REMARKS

AMENDED SHEET S/N 10/612,635

Fig. 2

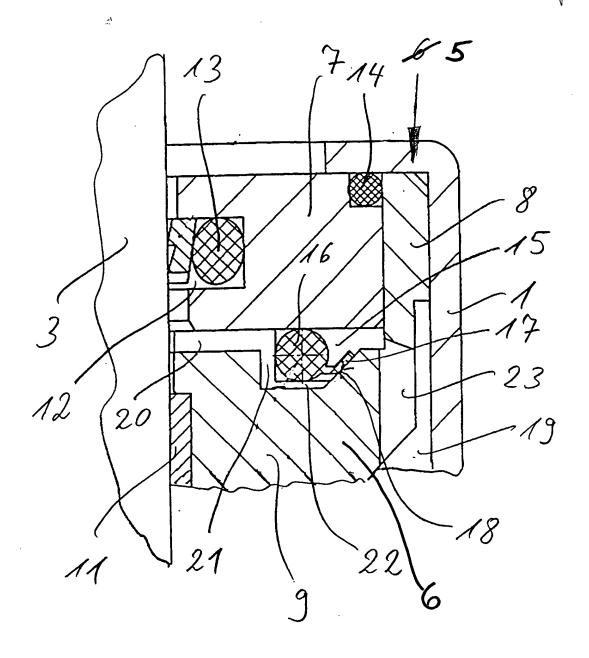
Thus, in considering the Examiner's comments and assumptions made with respect to the drawings, they appear to be based on an error in Figure 2. In Figure 2, the reference numeral 6 indicated there, should be correctly interchanged with the reference numeral 5, as noted in the amended and replacement drawing sheets that are being submitted. In Figure 2 considered by the Examiner, furthermore, the reference numeral 6 was omitted in error, and should designate the element as indicated in the amended and replacement sheets. Applicant notes, at the same time, that these reference numerals 5 and 6 are correctly shown in the drawing of Figure 1. As a result, no new matter is being introduced into the application through the present drawing amendment.

Furthermore, contrary to the Examiner's assumption, the "sealing seat" noted in the Office Action may not be considered as being located under the "circular ring 6", as noted by the Examiner in the Office Action. Instead, the "sealing seat" in applicant's invention is located on top of the piston-rod centering ring 6 and underneath sealing 16. This construction is shown in the corrected Figure 2.

In the Office Action on page 2, paragraph 1, last sentence, the Examiner comments that the views in Figures 1 and 2, "do not indicate that the cross-section of the circular ring is substantially circular shaped." From this comment, it is clear that the Examiner believes that reference numeral 6 designates a circular ring with a circular shaped cross-section. This, however, is not correct. Reference numeral 6 designates the "piston-rod centering ring 6," as shown in Figure 1 and by the corresponding section in applicant's specification. Thus, in applicant's specification on page 4, paragraph 2, sentence 3, line 15, as originally filed, describes "the wall of piston-rod centering 6 is approximately Z-shaped in cross-section."

In view of the preceding explanations, it is clear that the Examiner's correction requirements to the drawings are based on the Examiner's misinterpretations of the drawings. Apparently, these misinterpretations are partly due to the necessary interchange of the reference numerals 5 and 6 and the proper application of reference numeral 6 in the corrected drawing of Figure 2.

Applicant believes that in view of the corrections made to the drawing of Figure 2, the subject matter of applicant's invention is clarified and the assumptions made by the Examiner will be found to be based on misunderstandings of the Examiner in view of the following: By replacing the reference numeral 5 in the original drawing of Figure 2, with the reference numeral 6, and designating the piston-rod centering ring 6 that was omitted in error by the correct element as shown in the corrected drawing of Figure 2, it is believed that the Examiner will find the assumptions made in the Office Action to be incorrect.

Furthermore, the "sealing seat" is formed in applicant's invention by the conical surface 18 which cooperates with the "lip 17." Accordingly, the lip 17 and conical surface form together a check valve which prevents the gas in the gas accommodating space 19 from penetrating into the space between bushing 11 and seal 13. This feature is described in applicant's specification on page 6, paragraph 3.

Applicant is submitting both amended sheets as well as replacement sheets for the corrected drawing of Figure 2, as required.

It is believed that once the corrections to the drawing of Figure 2 are carried out as shown in the accompanying replacement sheet for that figure, the other drawing requirements set by the Examiner in the Office Action, are not further required.
